APPLICATION NO.	FILING DATE	FIRST NAMED INVENTOR	ATTORNEY DOCKET NO.	CONFIRMATION NO.
10/725,084	12/02/2003	Gilles Delapierre	117927	1747
25944	7590	05/19/2006	EXAMINER	
OLIFF & BERRIDGE, PLC P.O. BOX 19928 ALEXANDRIA, VA 22320			ANDUJAR, LEONARDO	
			ART UNIT	PAPER NUMBER
			2826

Office Action Summary

DETAILED ACTION

Figure 1 (Prior Art)

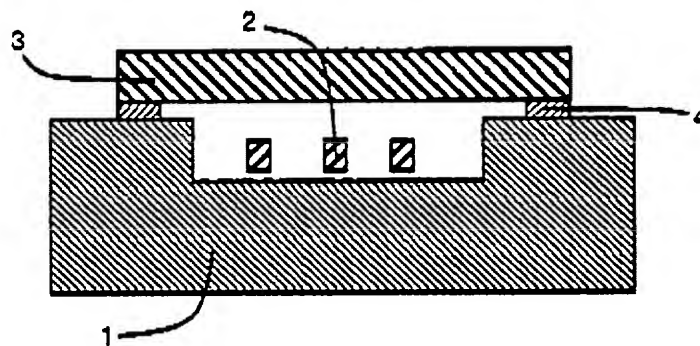
4. Regarding claim 1, Applicant Admitted Prior Art, hereafter APA, (e.g. fig. 1) shows a component for encapsulation of micro electromechanical systems integrated in a cavity, comprising a substrate 1 wherein the cavity is formed, a cover 3 presenting a front face and a rear face, arranged on the substrate, and means 4 for sealing the cover onto the substrate designed to make the cavity hermetic component wherein the cover includes a peripheral zone (i.e. the area outside the cavity) and a central zone completely covering the cavity.

However, APA does not show that the cover comprises at least one groove passing through the cover at the peripheral zone and a sealing material deposited at the bottom of a groove. Nevertheless, Ruby (e.g. figs. 1A, 2A) teaches a microelectronic component 10 having a cover 24 including grooves 26/28 passing through the cover and defining in the cover a peripheral zone and a central zone. Also, a sealing material 50 is located at a bottom of the grooves (see fig. 2A). According to Ruby, this type of
